City of Prescott

Prescott Preservation Commission

November 3, 2023 | 9:00 AM
201 N. Montezuma Street
Council Chambers, 3rd Floor
Prescott, AZ 86301

AGENDA

PROJECT:
UPGRADE EXISTING DIRECTIONAL SIGN
FOR SHARLOT HALL MUSEUM.

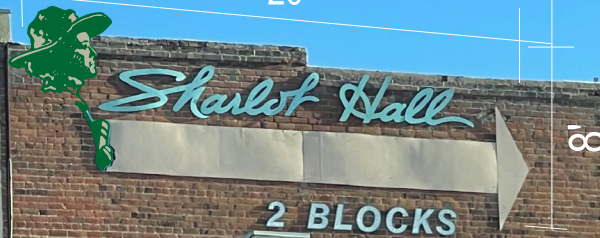
The applicant is seeking approval to replace the current, wall mounted directional sign on the north façade with new. It will read:

There will be a profile cut out of Sharlot Hall herself to the left of the text. The colours are off white, brown and darker red. Material to be PVC, mounted with alloy studs.

- Use historically consistent signage; use only flat against the building.
- Use only integral and natural colors of a neutral tone, compatible with the building and the district.
- Promote continued use of the Courthouse Plaza Historic District as a cornerstone commercial and business area with historically consistent and compatible development.

The proposed signage will not compromise the historic integrity of this building.

Recommended Action: Approve HP23-011. Request approval to replace wall mounted directional sign for Sharlot Hall Museum (22' x 6').
--

Site Plan

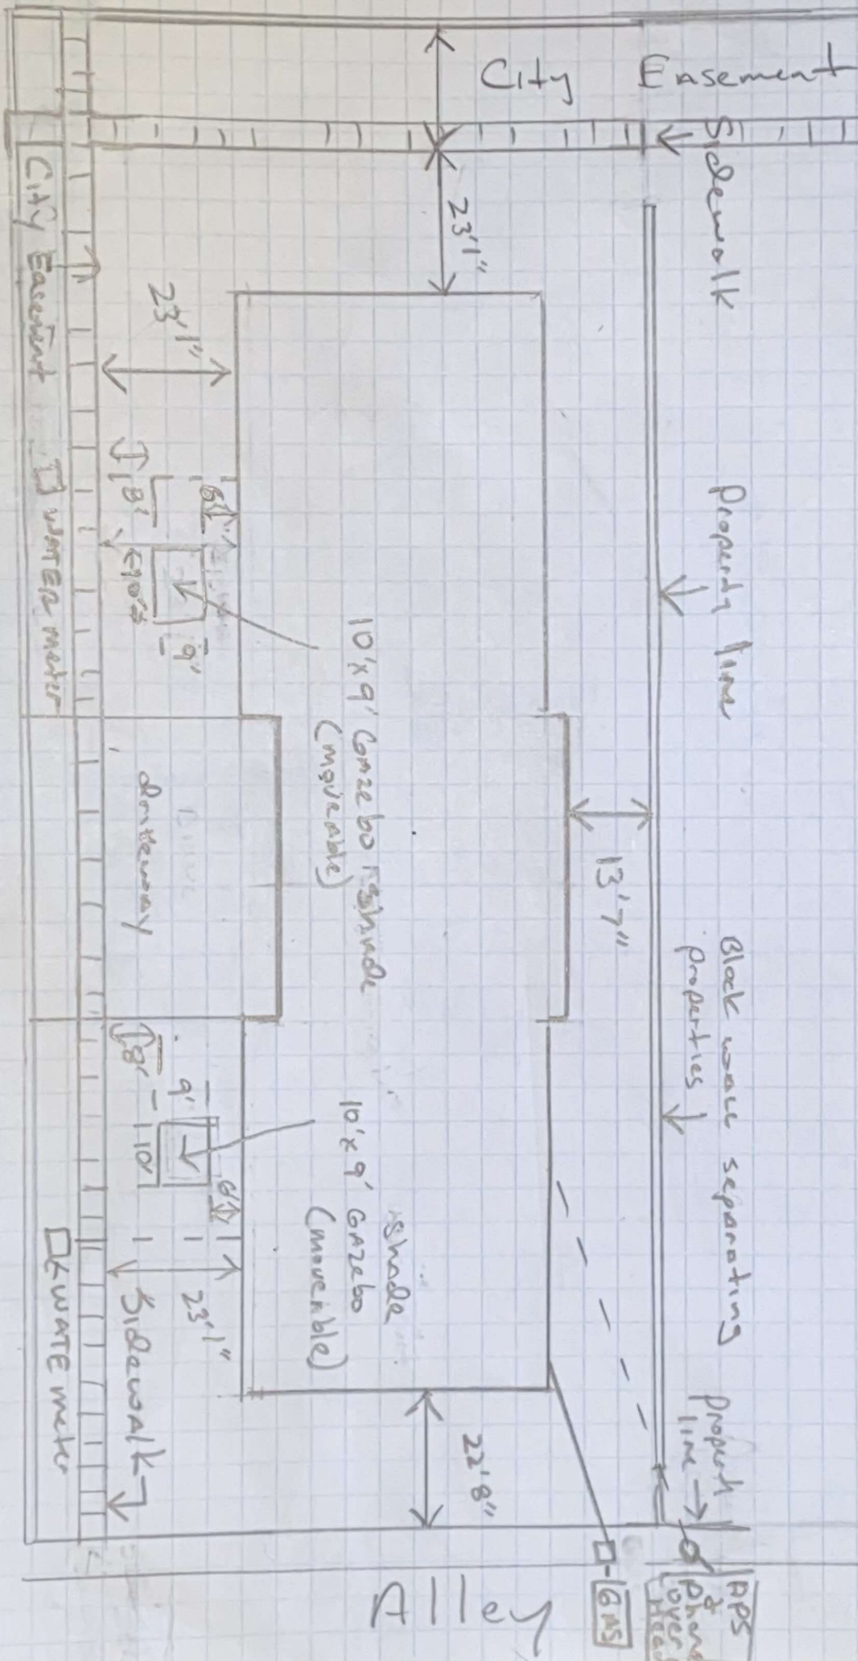
- Encourage wrought iron or open wood fencing at front of property.
- Other walls are constructed of concrete and either left as-is or covered with stucco...corner pillars and caps are also common and should be encouraged on new designs.
- As a rule of thumb, the siting of any new construction, additions or alterations should be compatible with neighboring structures, including those not immediately adjacent to the lot. Compatibility with both the streetscape and the historic siting should be followed at all times.
- Buildings that have been expanded over the years usually have additions to the rear of the property, maintaining the historic front facade on the street. Thus, proposed new buildings and rehabilitation projects should continue to emphasize the existing scale and massing of the neighborhood.

-Stucco walls are compatible as the home itself is mid century and there are several other stucco walls within both districts. The CMU caps and modern metal railing are not compatible, however.

-Proposed modification for fencing an improvement as it emanates a cedar split rail fence which is period & style appropriate for home.

-Style & materials of ramadas appropriate for the District. However, siting is not.

- Ramadas must meet side-yard setback of 7'
- Apply white, horizontal wooden planks on top of metal railings
